Tethered Snapper Pin

Product: Reelmaster®

March 29, 2019

Figure 1

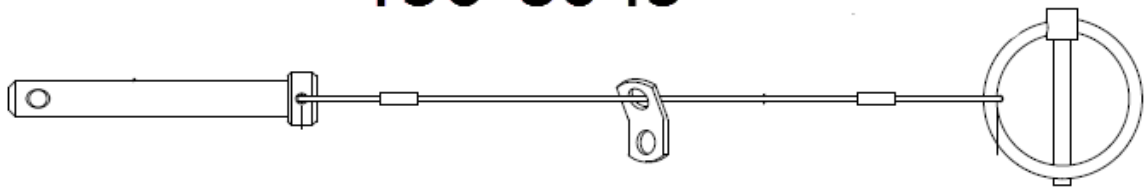
Toro has created a tethered pin to hold the cutting unit to the lift arm. The tether will retain either side of the pin in the event a pin breaks during operation which will keep the pin from damaging the reel or bedknife.

Pin and Lanyard assembly is part # 136-8045 and can be installed on most Reelmaster product to ensure pins are not lost and will not go through the reel if they break during operation. See Figure 1 for part image. Note - The small metal bracket attaches under the grease zerk on the lift arm.
